SHEET 22 OF

CITY OF HARTFORD, CONNECTICUT DEPARTMENT OF ENGINEERING		
CEMETERY BROOK CONDUIT		
SUBMITTED	RECOMMENDED	APPROVED
DIVISION ENGINEER	ASST. CITY ENG.	CITY ENGINEER
DESIGN	DRAWN	DAYBOOK NO. 09430
TRACED	CHECK	DATE NOVEMBER 1956

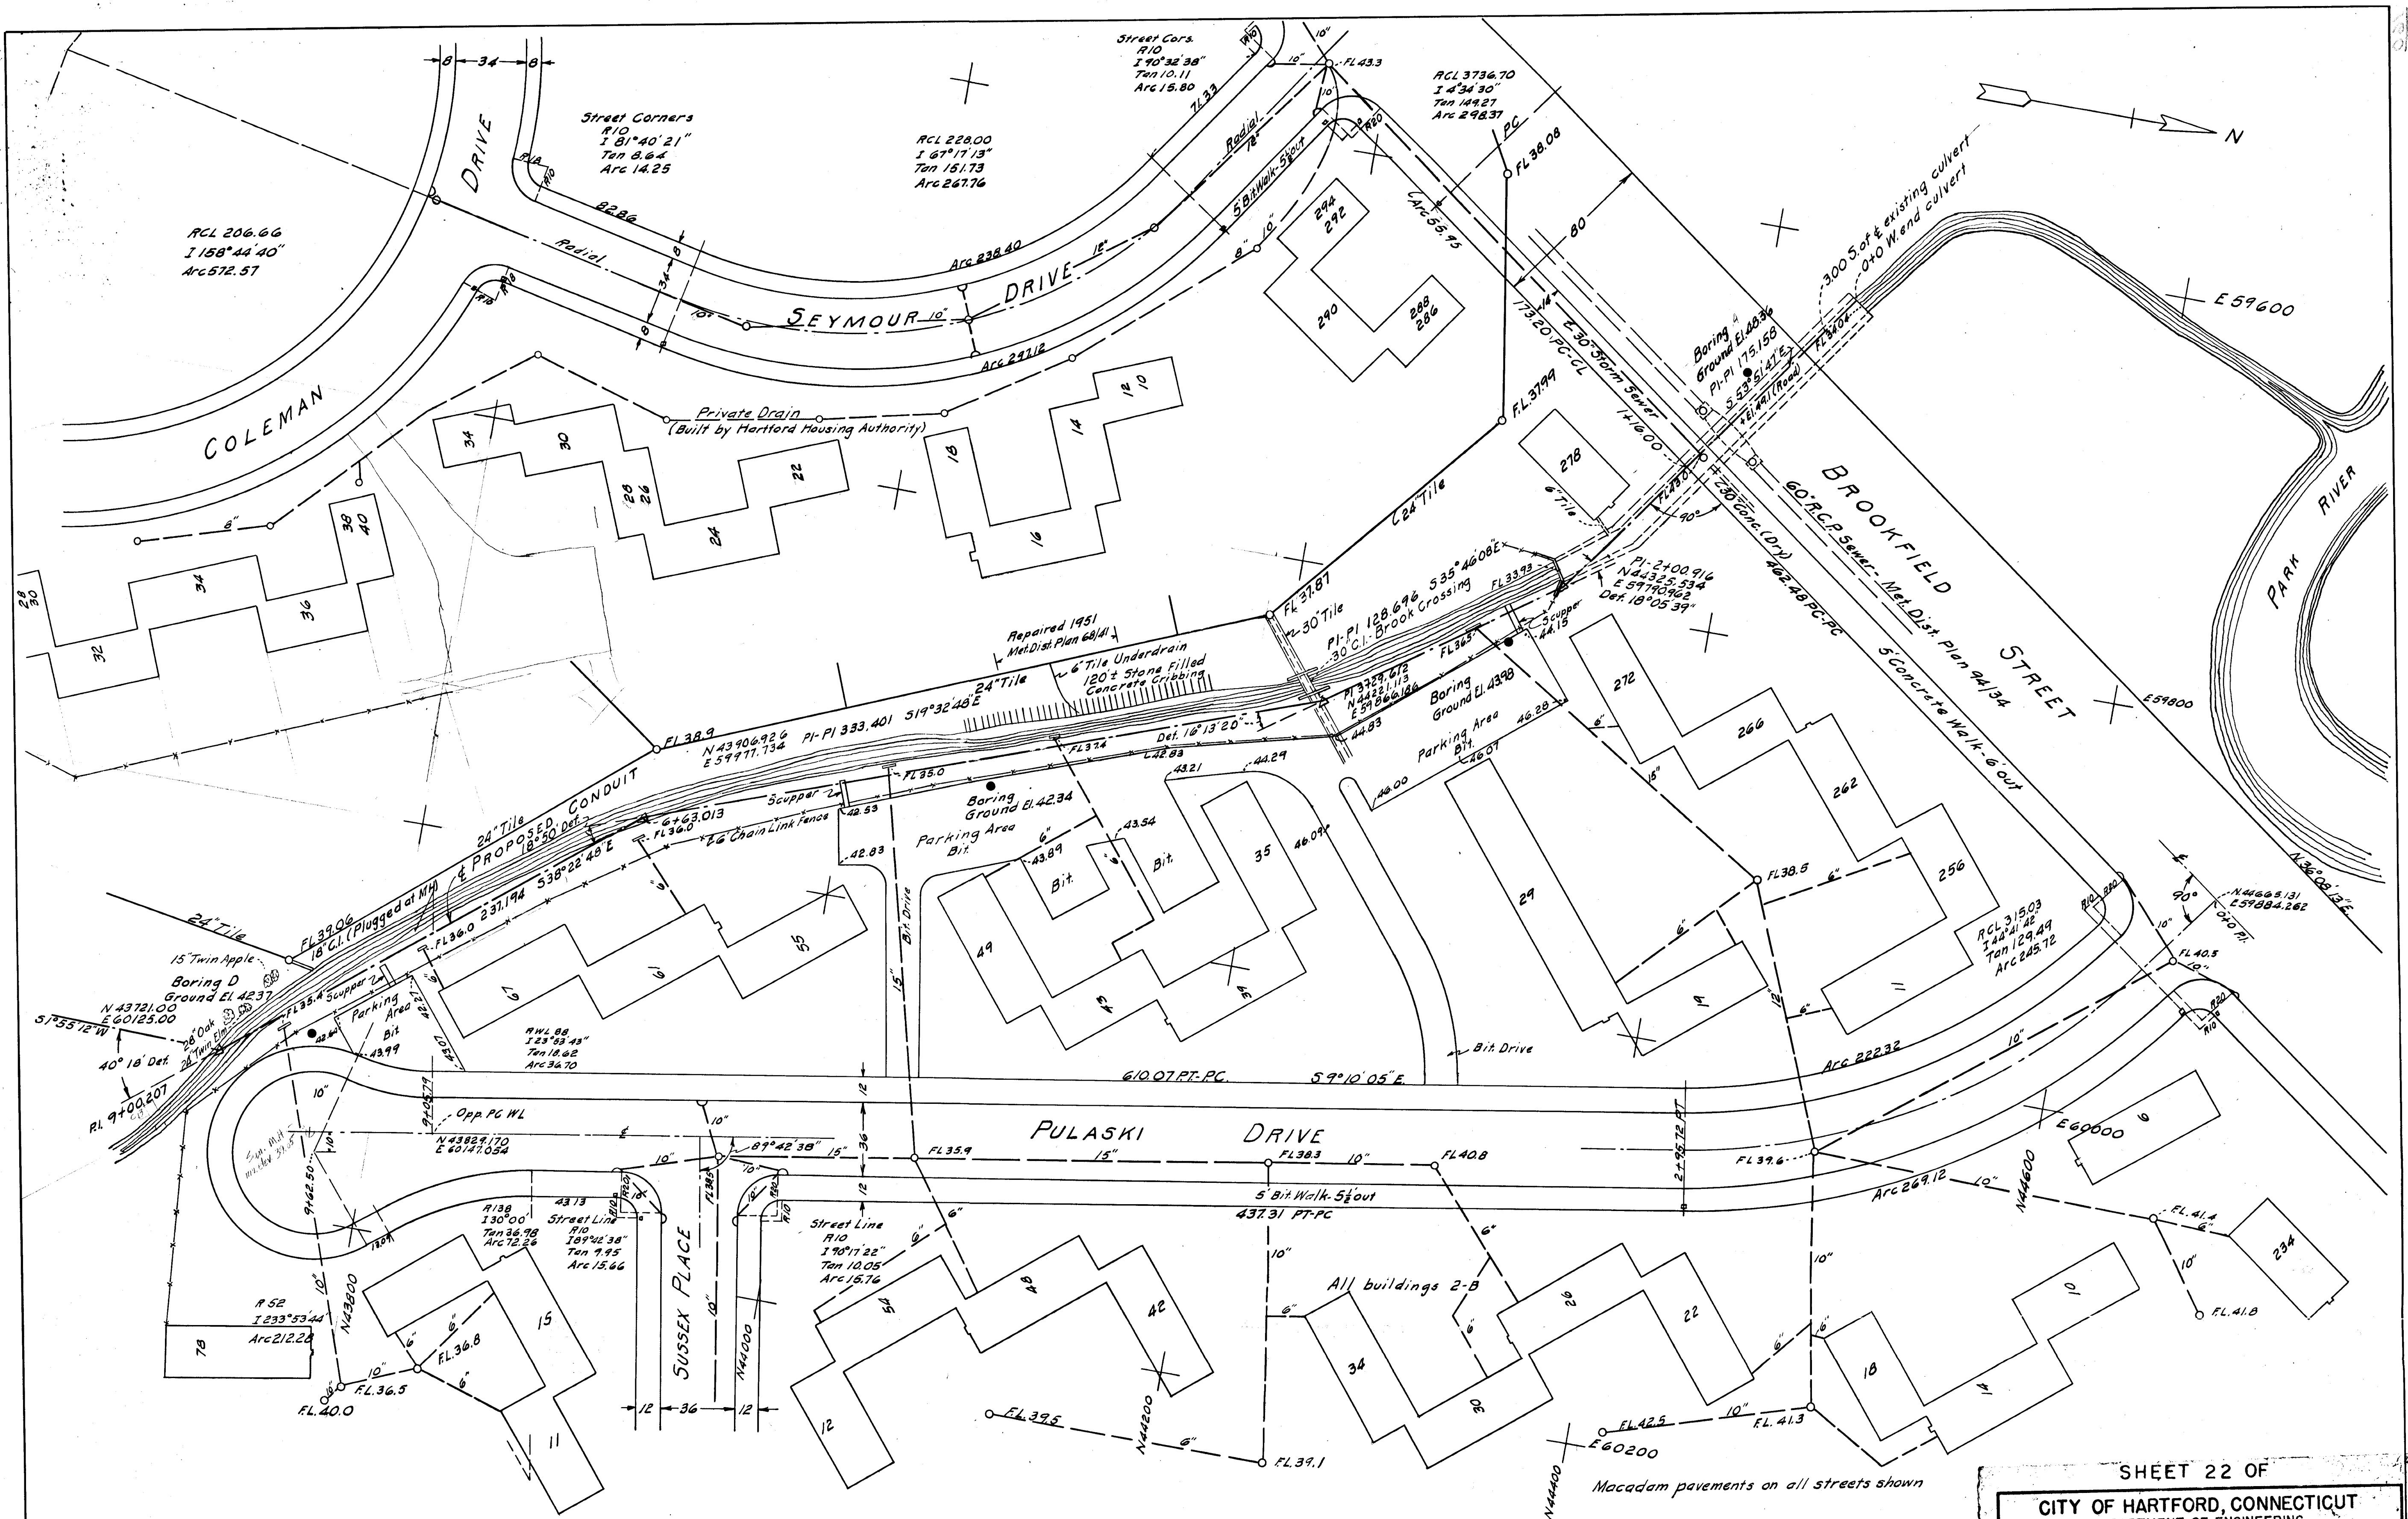
Revision of April 3, 1957 - Center line of proposed conduit plotted

Revisions of Nov. 7, 1957 - & Conduit moved 8' east of former location from Sta. 2+00.916 to Sta. 6+63.013

Revision of Jan. 15, 1957 - Elevations in parking areas plotted

Revision of Jan. 2, 1957 - Buildings and storm drains East of Pulaski Drive plotted
